## ATTACHMENT 1 – Council Submission

Development Application (DA-2023/170) was approved by the Sydney North Planning Panel on 9 October 2024. This approval involved demolition of existing structures and the construction of a 27 storey shop-top housing development comprising a two-storey commercial podium and a 25-storey residential tower.

The subject SSDA is a new application, involving the following timeline:

**Left image: Landscape Plan showing planting and new tree.**

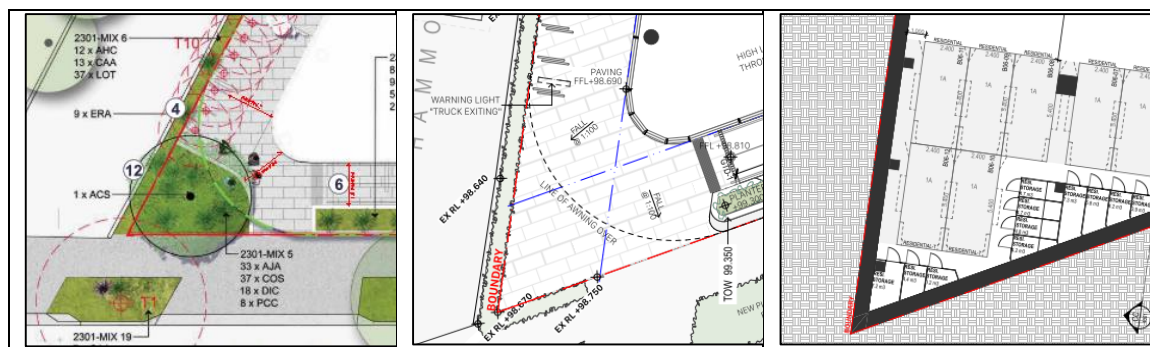
There is no deep soil provided to the Gordon Avenue and Hammond Lane frontages. The landscape plan shows landscaping to the corner of Gordon Avenue and Hammond Lane with a proposed canopy tree. The architectural plans show the area paved, with no planting and basement structure below.

Truncating the corner of the basement in the SW corner of the site could facilitate for some deep soil and to accommodate a canopy tree.

Provision of no deep soil planting to Gordon Avenue is not supported. Having particular regards to the geometry of the site, the opportunity exists to provide deep soil planting and a canopy tree on the corner of Gordon Avenue and Hammond Lane.

Basements are to be set back from the Gordon Avenue and Hammond Lane corner to allow for deep soil planting and at least one canopy tree. The geometry of the site allows for this opportunity to provide and achieve a meaningful green presence at ground level.
